**ESR HORSLEY  
LOGISTICS PARK -  
SSD-10436 MOD 1**

Section 4.55(1A) Modification

Director	Jacqueline Parker
Consultant	John Booth
Project Code	P0020568
Report Number	MOD 1 – Rev 1

Figure 2 Lot 201 Site & Facility Plan

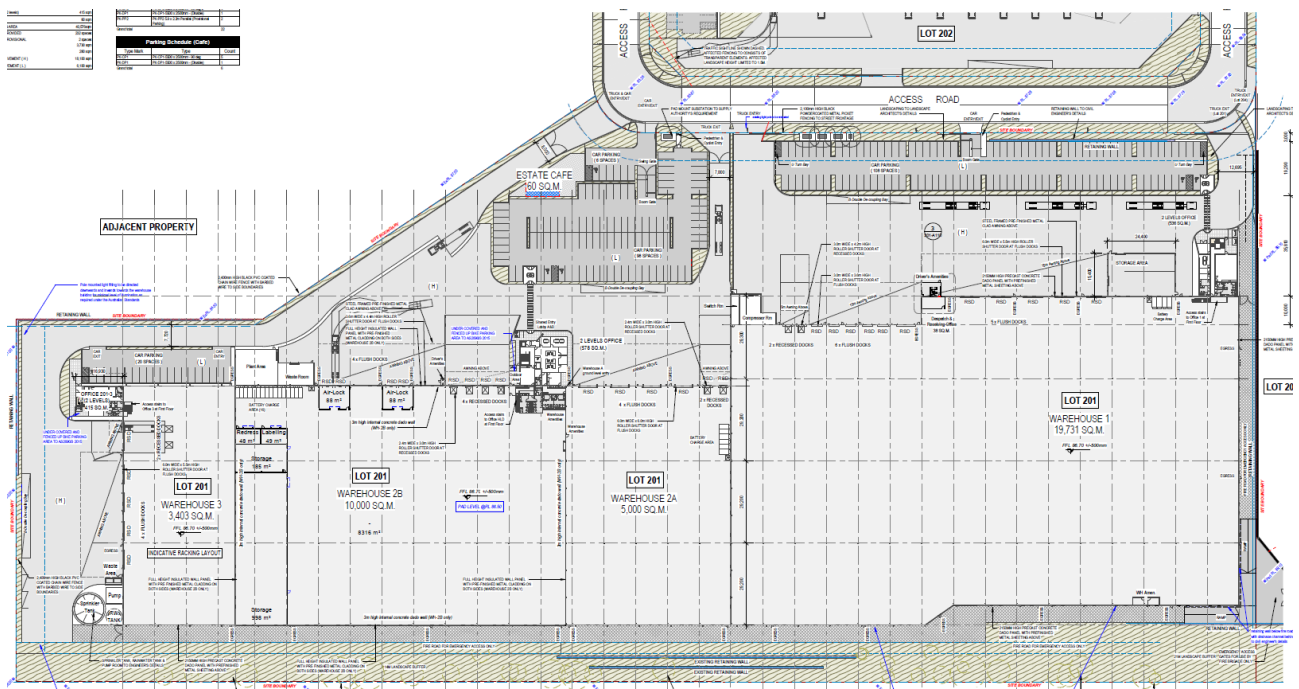
- Reconfigured building footprint and geometry including the extension of the building footprint to the west by 90 metres;
- Conversion of the reconfigured warehouse from a single tenancy to three tenancies, including the erection of inter-tenancy wall panels (note: Warehouse 2A and 2B form two components of a single Warehouse 2 tenancy);

- Reduction in overall warehouse maximum GFA from 42,233m<sup>2</sup> to 38,134m<sup>2</sup>;
- Increase in office maximum GFA from 1,095m<sup>2</sup> to 1,529m<sup>2</sup>;

- Redistribution of the 232 car parking spaces from the lot's western boundary to include:
  - 20 spaces north of proposed Warehouse tenancy 3,
  - 98 spaces with direct access from Johnson Crescent supporting proposed Warehouse tenancy 2, and

- 108 car parking spaces north of proposed Warehouse tenancy 1 also with direct access from Johnson Crescent;
- Relocating of loading areas and access points for each proposed new tenancy;

- Introduction of 10 recessed docks and 23 flush docks to facilitate the operation of the three tenancies;
- Inclusion of storage area north of Warehouse tenancy 1;

- Allocation of space for a future estate café (construction and fit-out subject to separate approval); and
- Relocation of the approved pump room and sprinkler tank to the lot's western façade.

Figure 3 Lot 204 Site & Facility Plan

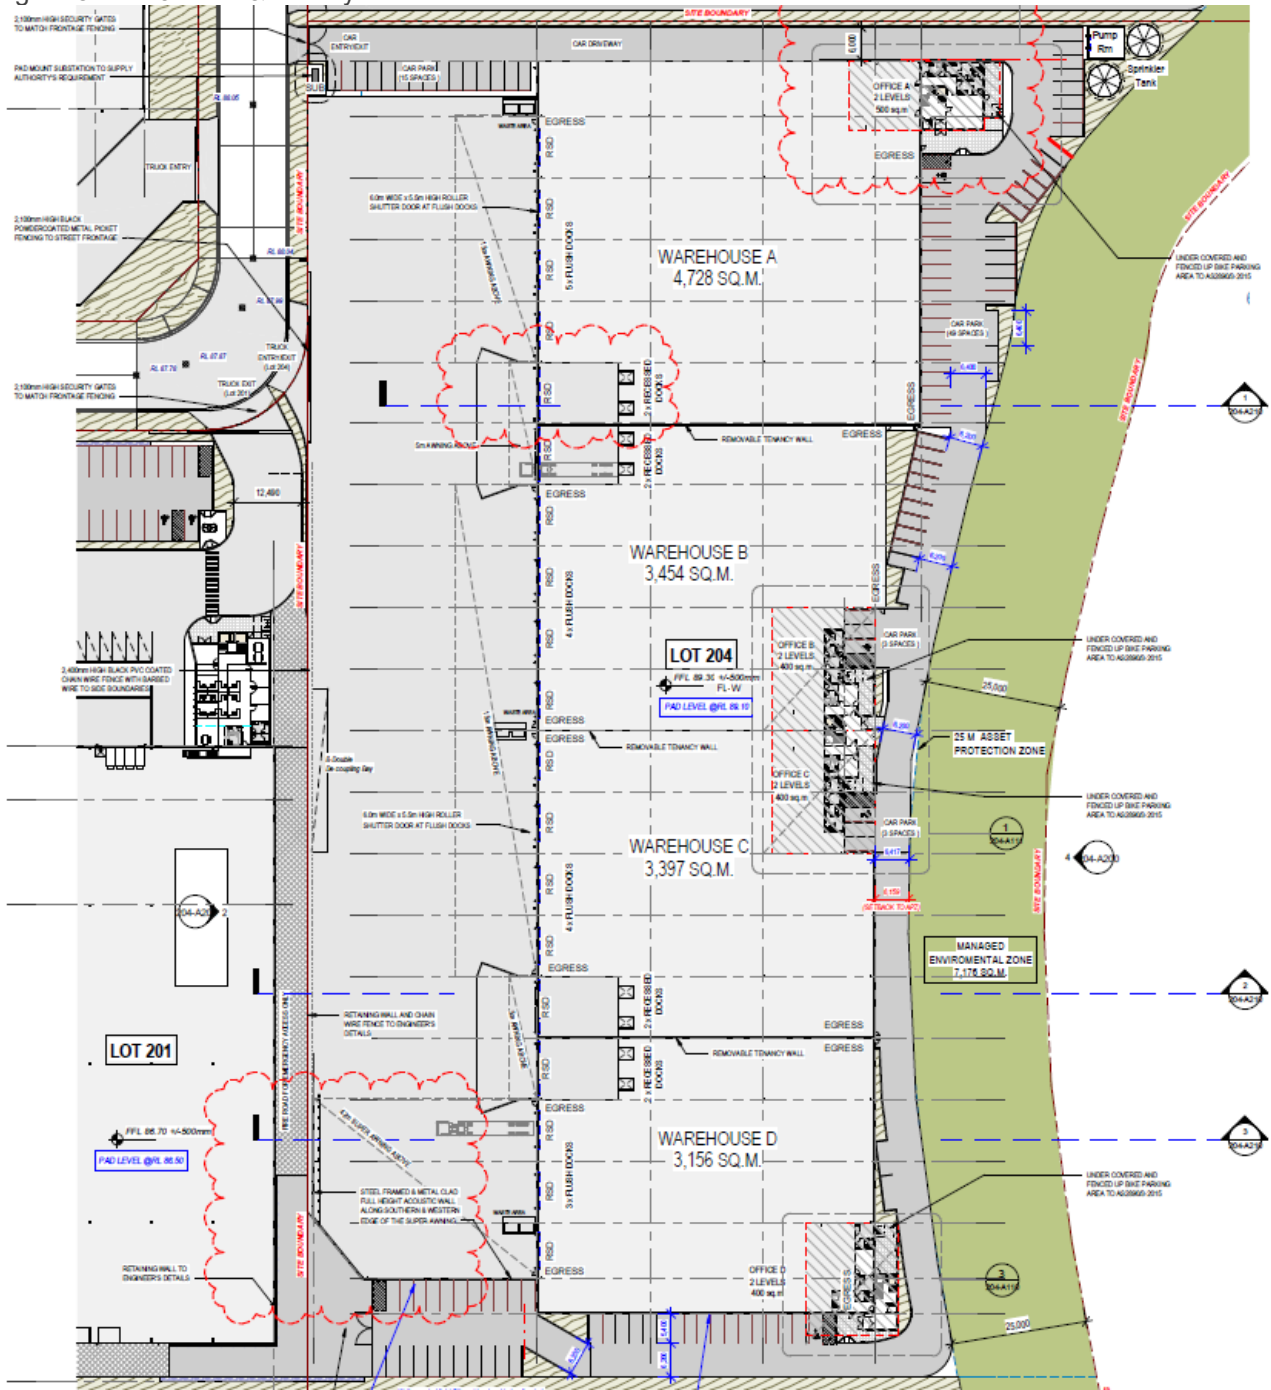
- Increase in warehouse maximum GFA from 14,524m<sup>2</sup> to 14,735m<sup>2</sup>;
- Reduction in office space maximum GFA from 1,977m<sup>2</sup> to 1,700m<sup>2</sup>;
- Car parking reduced from 117 spaces to 114 spaces;
- Inclusion of an additional two recessed docks within Warehouse A; and
- Reconfiguration of the hardstand area fronting Warehouse D to provide additional manoeuvring space for trucks accessing the Fire Road for emergency access.
